MILITARY SPECIFICATION

REPRODUCER, SIGNAL DATA: AN/GSQ-64
(READER, PUNCHED TAPE)

This amendment forms a part of Military Specification MIL-R-46332A(MU) dated 10 March 1965.

FIGURE 2

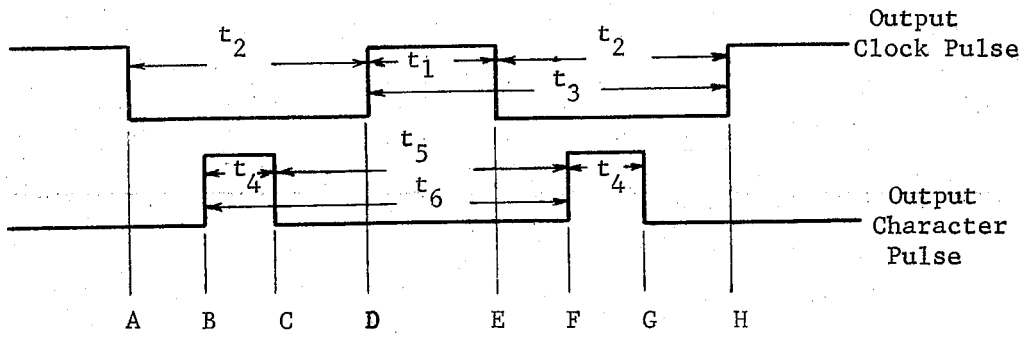
* Delete Figures 2 and 3 and substitute new Figure 2.

1. DE = t_1; AD = EH = t_2
2. DH = $t_1 + t_2 = t_3$ = One Clock Cycle
3. BC = FG = t_4; CF = t_5
4. BF = $t_4 + t_5 = t_6$ = One Character Cycle
5. DH = BF = 2.25 msec $\pm$ 10% = One Cycle
6. CF = t_5 = 1.54 $\pm$ .05 msec at room ambient
7. When clock and character pulses are displayed on a dual trace oscilloscope, the distance AB and/or EF shall be greater than 8% of one cycle.

"Pulse duration for t1 + t2 shall be 2.25 msec ± 10%. The normal pulse duration for t5 shall be 1.54 ± .05 msec. At temperature extremes the pulse duration for t5 shall be $1.54 \begin{smallmatrix} +.3 \\ -.1 \end{smallmatrix}$ msec."
